City of Madison, Wisconsin

REPORT OF: URBAN DESIGN COMMISSION

TITLE: 1801 East Washington Avenue – New Development, One 4-Story Building Containing 228 Apartment Units and 8,900 Square Feet of Commercial Space in UDD No. 8. 6th Ald. Dist. (40143)

PLANNING DIVISION STAFF REPORT

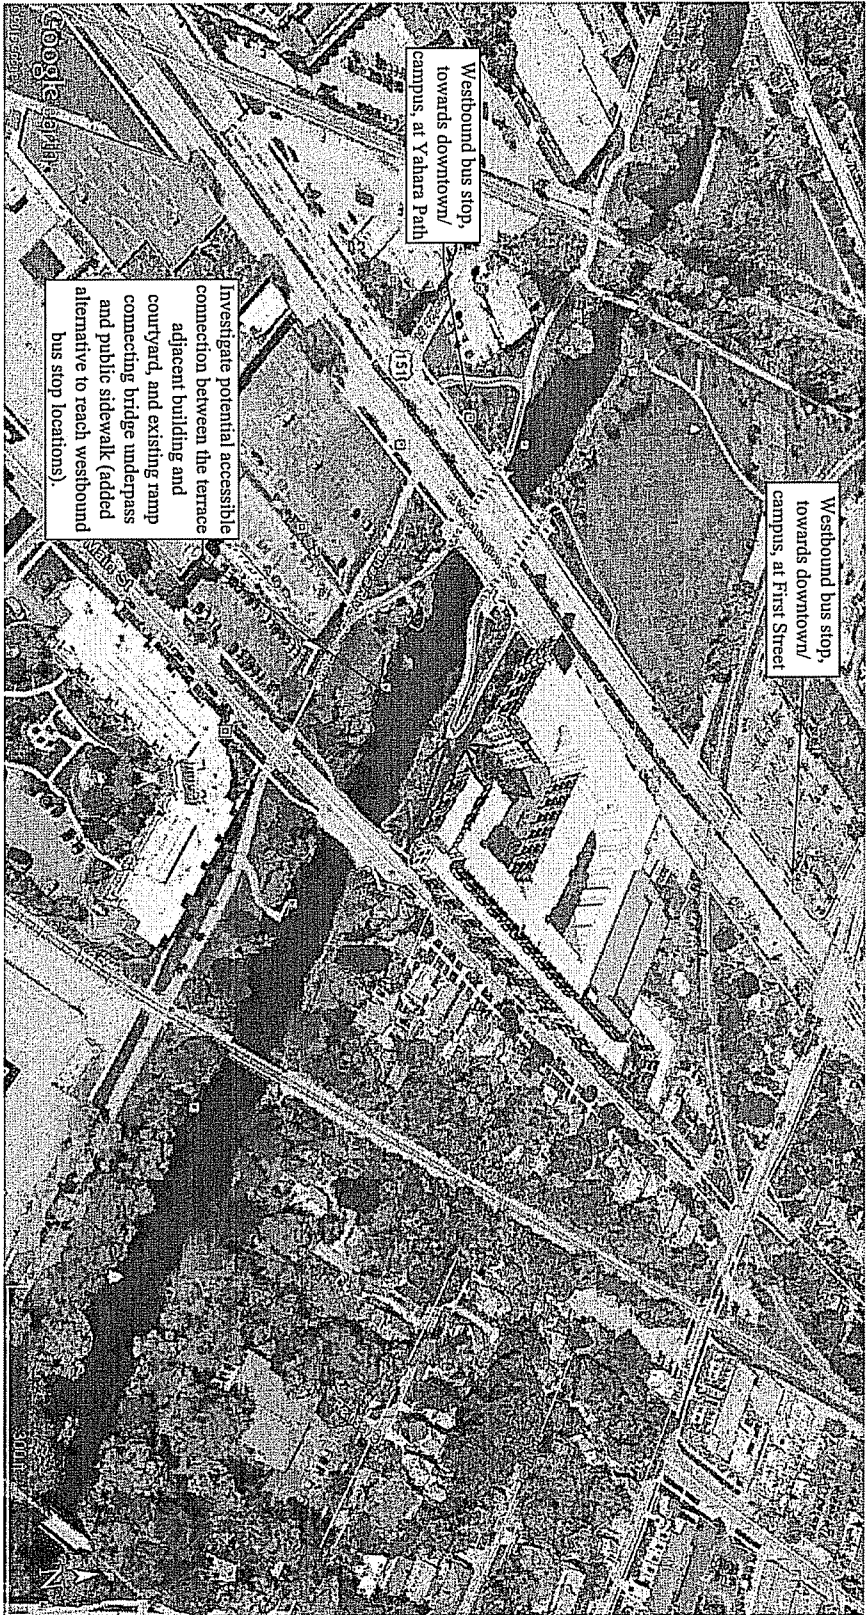
- Along the 600 foot East Washington Avenue frontage, the plan includes six oak trees and two lilacs. In addition, one significant existing street tree will be protected to remain on the site. The trees in this area do not in and of themselves meet the ordinance requirement for canopy trees planted every 40 feet, but even with fewer additional public trees than currently shown on plans, it should be possible to meet this requirement.
- Along East Main Street, four existing street trees will remain, and shrubs and low perennials have been proposed in the space between the new public sidewalk and the building. The UDC should carefully review this area to ensure that the landscape plan is optimal.

- Along the West side of the building facing the Yahara River, the applicant has proposed a pathway leading from East Main Street to East Washington Avenue in an area where a public easement will be required. Low landscaping is proposed just east of the path along the building foundation. The applicant has enhanced the landscaping in this area based on feedback from the Landmarks Commission. Six canopy trees are proposed along the west side of the path, three of which appear to be shown on the property line itself. Staff from the Parks Division is currently reviewing this plan, and may recommend that the placement of these trees be slightly adjusted to avoid the property line.

- Along the east side of the exposed parking garage, several canopy trees are proposed to soften the facade. While this facade will not be highly visible, the proposed trees and other landscaping will soften the views from the railroad track and single-family homes further to the east.

- Finally, the three courtyard areas include a wide variety of relatively dense plantings ranging from low perennials to canopy trees, organized around central lawn or hardscaped areas. Seating and other amenities are included in the two larger courtyards, and vegetable garden spaces for tenants are shown in the courtyard opening up to East Main Street, where ample sunlight should support them.
